# DEVELOPMENT REVIEW BOARD REPORT

**McDowell Hayden  
Retail  
32-DR-2021** | Request for approval of a site plan, landscape plan, and building elevations for two (2) separate pad buildings on a +/- 1.4-acre portion of a +/- 2.6-acre site.

**LANDSCAPE PLAN**

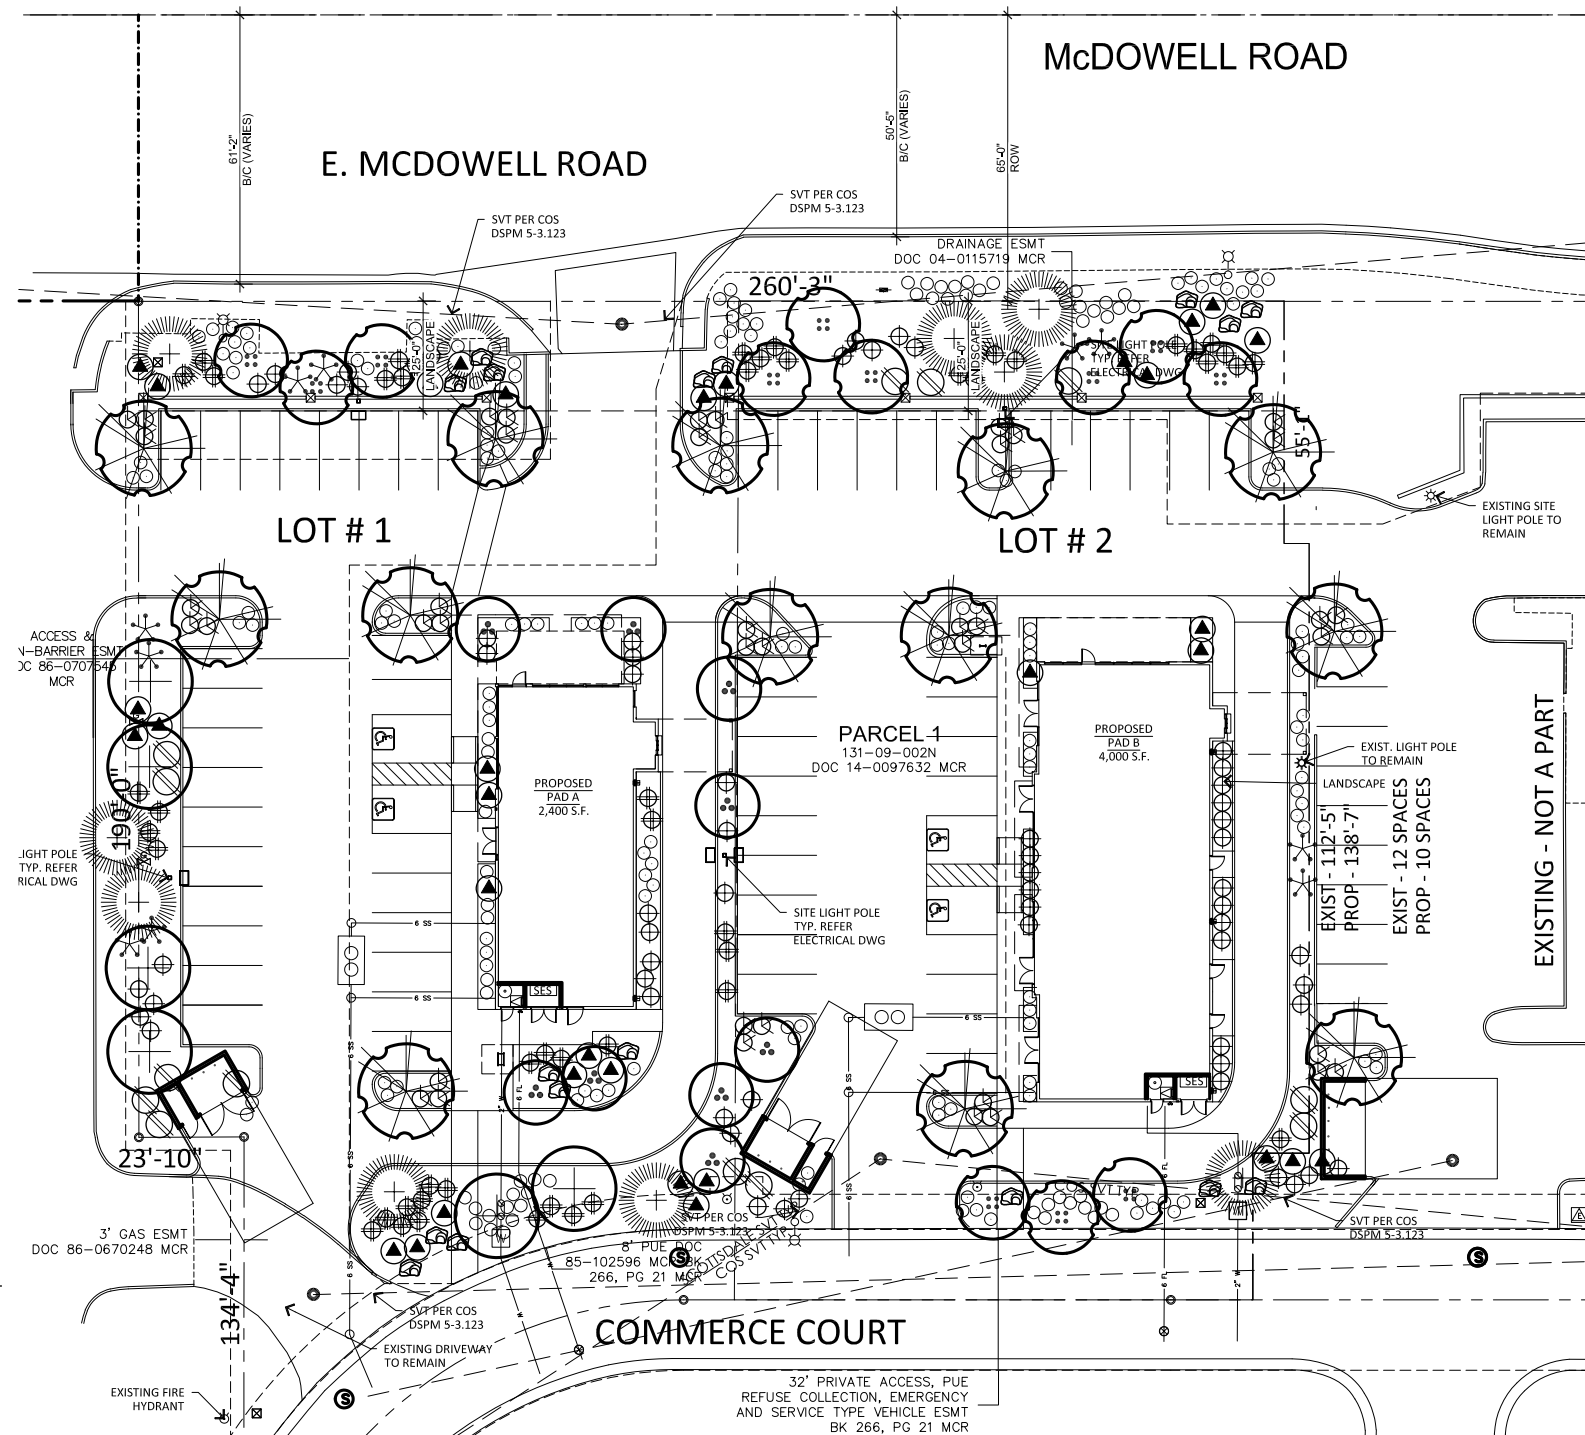
<b>COMMENT</b>	
Comment:	RE: McDowell Hayden Retail Project, 94-PA-2021 When is the public meeting for project? The landscaping/streetscape looks minimal in the plans. Looks like there is room for a little tweaking to add more plant coverage to help mitigate the heat effect and to also protect the South Scottsdale aesthetics. As a high density area, these are important factors that affect the city (and the valley) as a whole. South Scottsdale needs development, but with an eye on aesthetics and quality of life (like at the northern end).
Comments are limited to 8,000 characters and may be cut and pasted from another source.	
<b>PLEASE PROVIDE YOUR NAME:</b>	
First & Last Name:	Susan L Armanovs
